APPLICATION NO.	FILING DATE	FIRST NAMED INVENTOR	ATTORNEY DOCKET NO.	CONFIRMATION NO.
18/698,915	04/05/2024	Tetsu MORISHIMA	228963	3163

Office Action Summary	Application No. 18/698,915	Applicant(s) MORISHIMA et al.	
	Examiner Eric K Wong	Art Unit 2874	AIA (First Inventor to File) Status Yes

DETAILED ACTION

FIG. 4A

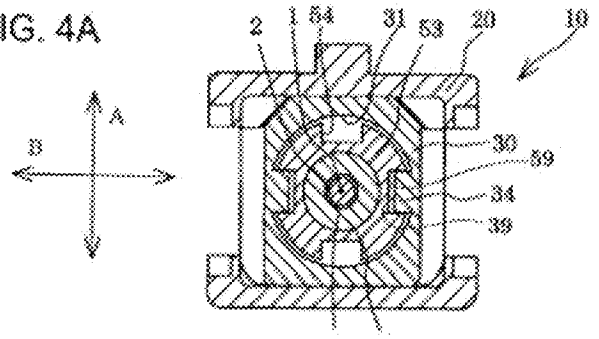
Inagaki discloses a round-type profile having a recess between two contact points (figure 4A).

It would have been obvious to one having ordinary skill in the art to swap the recess portion to be between two contact points as taught in Tiara in the square-type shape of Shimikawa as a design choice for a change in size, shape, rearrangement or reversal of parts. *In re Japikse*, 86 USPQ 70, *In re Rose*, 105 USPQ 237 (CCPA 1955), *In re Einstein*, 8 USPQ 167.
